**TOWN OF CARMEL**  
**PLANNING BOARD**

**PLANNING BOARD AGENDA**  
**SEPTEMBER 27, 2017 – 7:00 P.M.**

Stonefield Engineering and Design, LLC ("Stonefield") is pleased to resubmit documents for the above-referenced project. Revisions were made to the Site Plan to address the comments issued by the Department's review letter dated September 13, 2017. The following is an itemized response to each comment:

In response to the initial comments offered by various Town offices after their review of the S-M Line Gas Distribution Reinforcement Project, Maser Consulting responds with the following information.

SITE PLAN

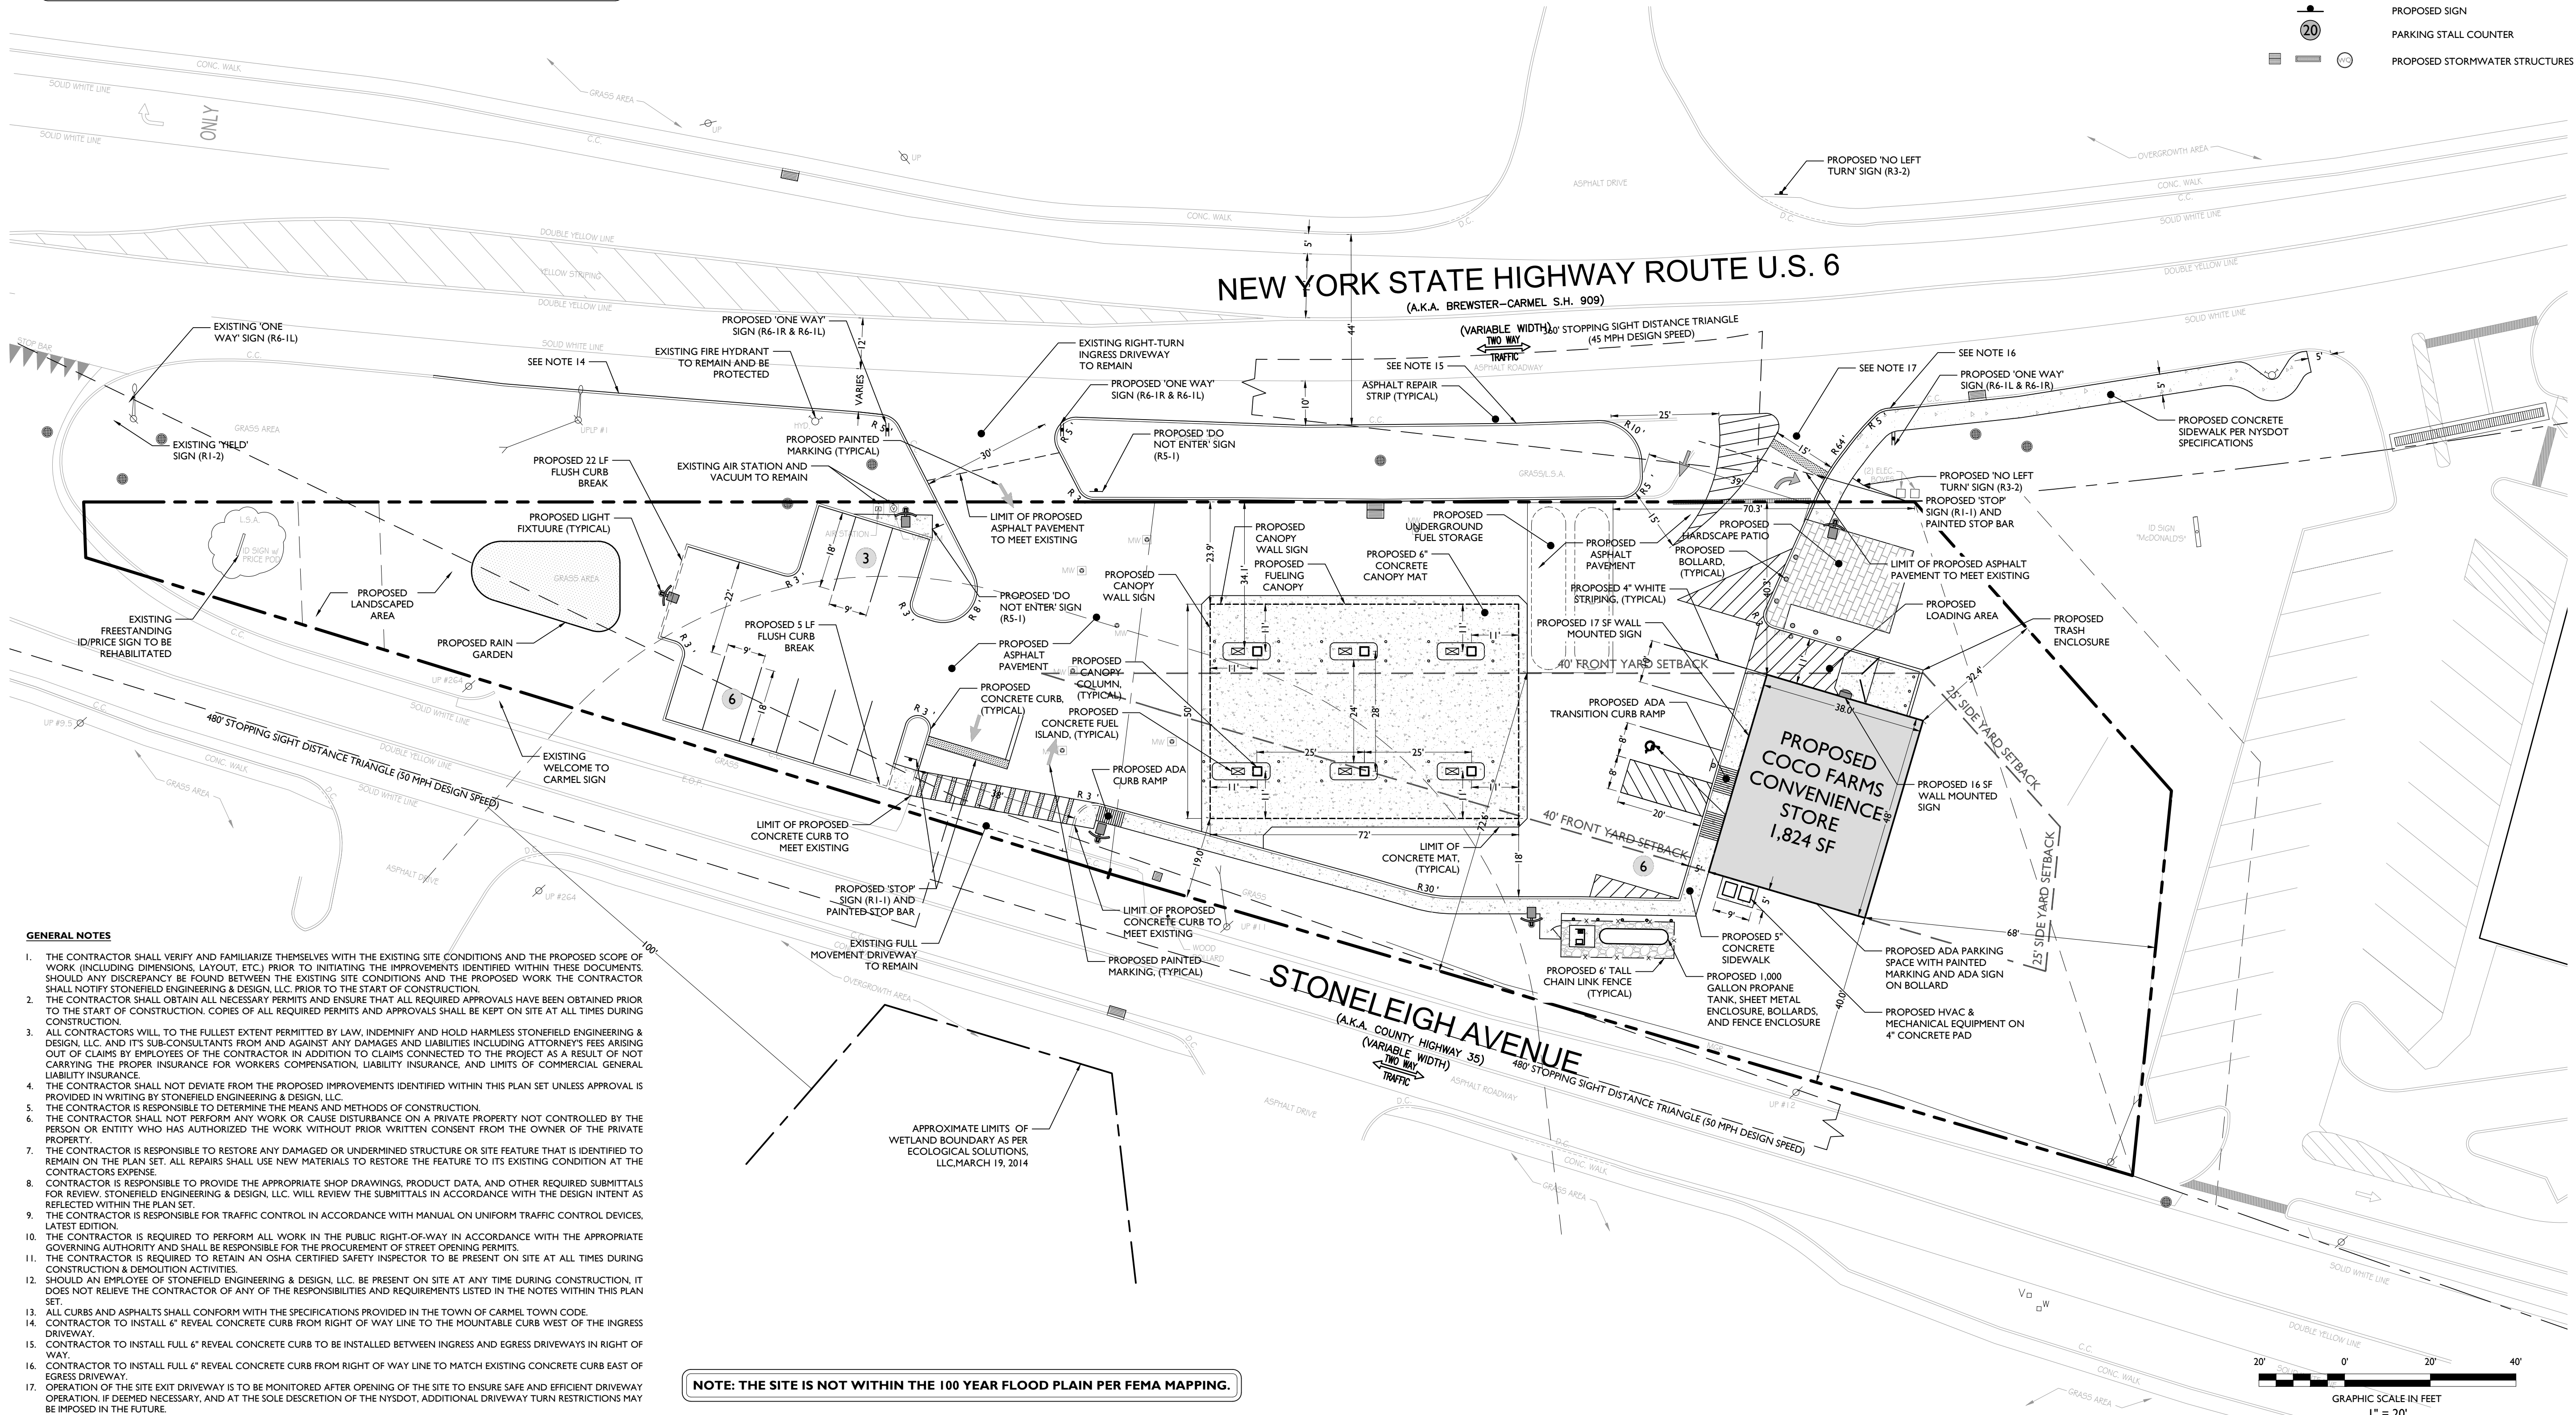
- 1) The proposal to allow left turns into the site from Route 6 at the eastern entrance is conditionally approved. Should operational difficulties or an accident pattern develop the Department will impose a left turn ingress restriction. We require that the following note be added to the plans, called out to the eastern driveway: "OPERATION OF THE SITE EXIT DRIVEWAY IS TO BE MONITORED AFTER OPENING OF THE SITE TO ENSURE SAFE AND EFFICIENT DRIVEWAY OPERATION. IF DEEMED NECESSARY, AND AT THE SOLE DISCRETION OF THE NYSDOT, ADDITIONAL DRIVEWAY TURN RESTRICTIONS MAY BE IMPOSED IN THE FUTURE."

- 7) The proposed permit work is near a NYSDOT traffic signal, highway light, or other device with loop detection and/or buried conduit. The permittee shall locate all such underground facilities and note such on the construction plans. Damage to underground facilities are the responsibility of the permittee. Signal loops and conduit are not covered by UFPO call out and require a separate call out notification to the NYSDOT.

**Response: This comment is noted. The requested note was added to the Site Plan and is called out at the easterly driveway along U.S. Route 6.**

**Response: As shown on the Site Plan, the easterly driveway has been designed to accommodate two-way traffic.**

**Response: As shown on the Site Plan, MUTCD-compliant signage restricting left-turn egress is provided at both driveways along U.S. Route 6.**

**Response: The Site Plan shows milling and repaving of the shoulder adjacent to the site. This improvement was requested by Mr. Rock DeNigro during earlier reviews of the Site Plan.**

**Response:** This comment is noted. Note 18 was added to the Site Plan to address the above.

***Figure 2.2 – View from Proposed Driveway looking west on Bullet Hole Road***

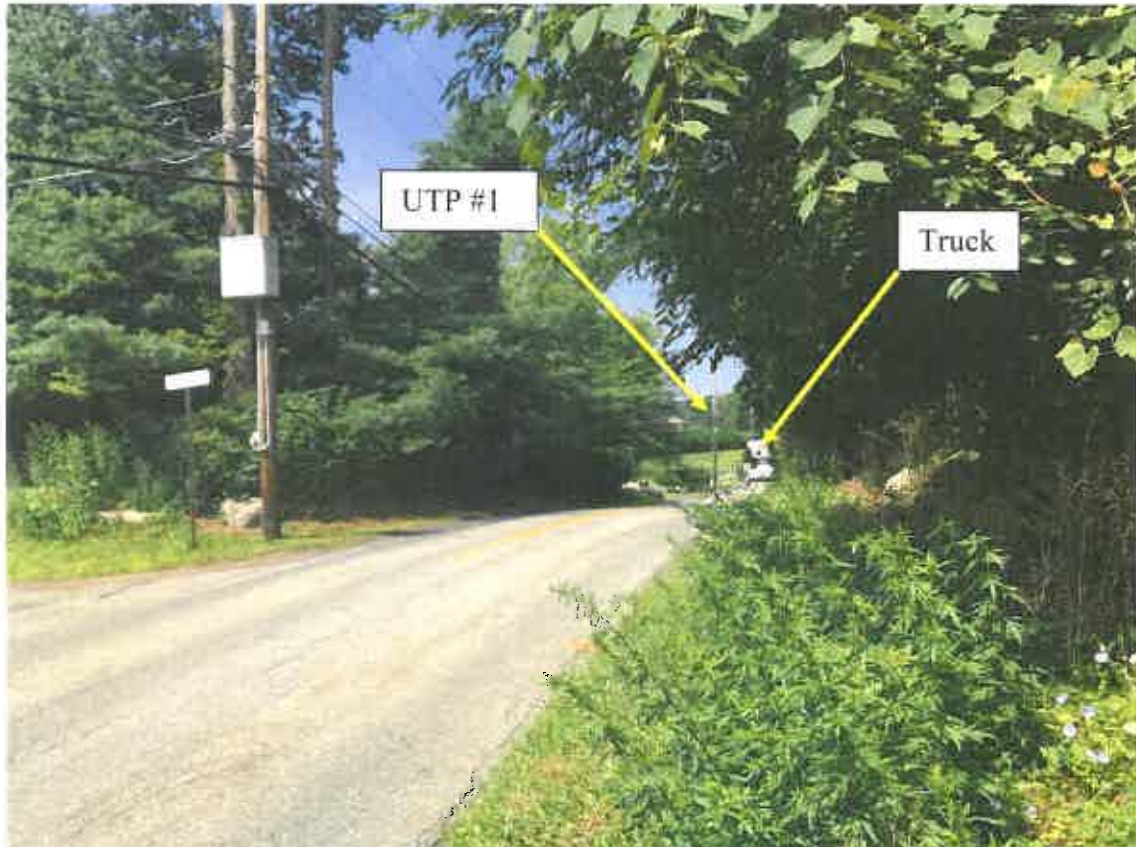
4. Available sight distances at each driveway location should be specified on plan. Any clearing along the edge of the roadway R.O.W. that may be necessary to assure appropriate sight distances are provided, should be identified.

Sight distance to the west was measured at 246.39 ft. to existing utility pole #1 shown in Figure 2.2. At the time, the picture in Figure 2.2 was taken a Ryder rental truck was approaching the site. It can be seen from the proposed driveway location at a farther distance than utility pole #1. However, its location cannot be compared to the project's survey. It is estimated to be approximately 275 ft. in the background from the proposed driveway.

Sight distance to the east was measured at 359.25 ft. to existing utility pole #4 shown in Figure 2.3. On the opposite side of Bullet Hole Road, a mailbox and existing driveway can be seen in the middle-ground of Figure 2.3. This existing driveway is approximately 200 ft. from the proposed driveway location.

Sight distance measurements show the proposed driveway for 340 Bullet Hole Road will meet and exceed the requirements of 200 ft. per Town of Carmel's code. In proposed conditions, the sight distance may improve when existing brush/vegetation in the ROW in front of 340 Bullet Hole Road is removed. Proposed landscaping trees will be set approximately 12 ft. into the property from the edge of pavement and therefore, should not hinder intersection sight distances.

**SHEET TITLE:** DETOUR PLAN

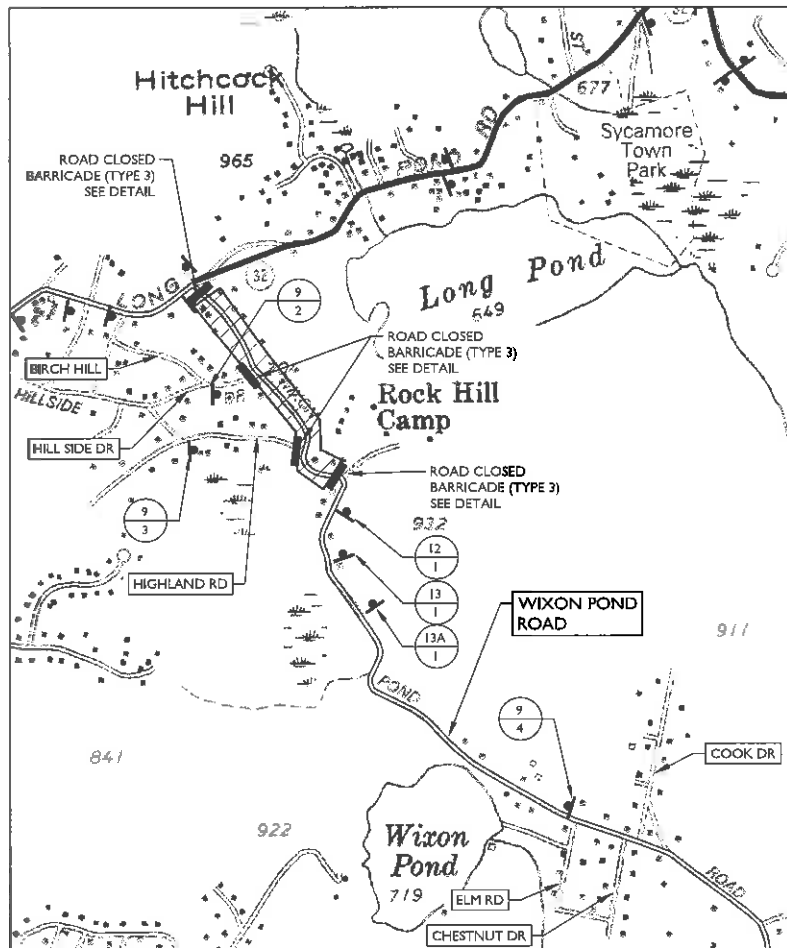
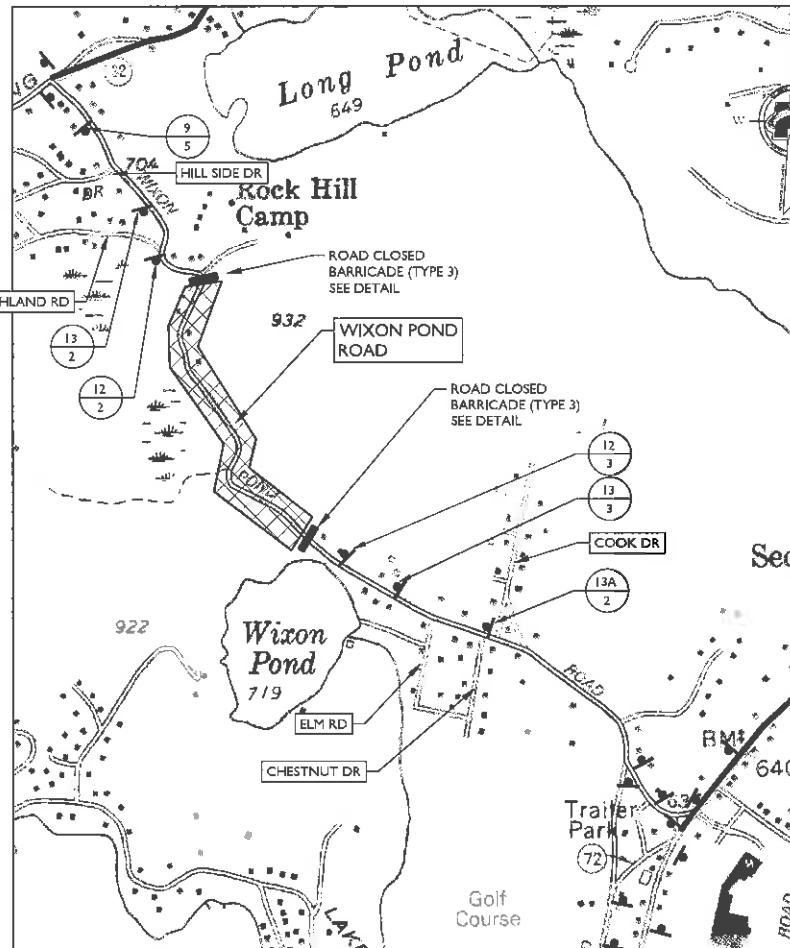
6. Protection and management of traffic (no plan has been provided). The Town needs to receive a traffic plan that includes any detours (minor/major) or road closures with all the appropriate signage that would be provided.

**Response:** *A Work Zone Traffic Control Plan (“Details”) was provided in previous project plan submittals. However, during the meeting it was noted the Superintendent of Highways did not receive a set of project plans to review. This submittal includes an extra set of plans specifically for the Superintendent of Highway, and now includes a Detour Plan, Road Closure Plan and Sign Text Detail Plan along with the pre-existing Work Zone Traffic Control Plan (“Details”).*
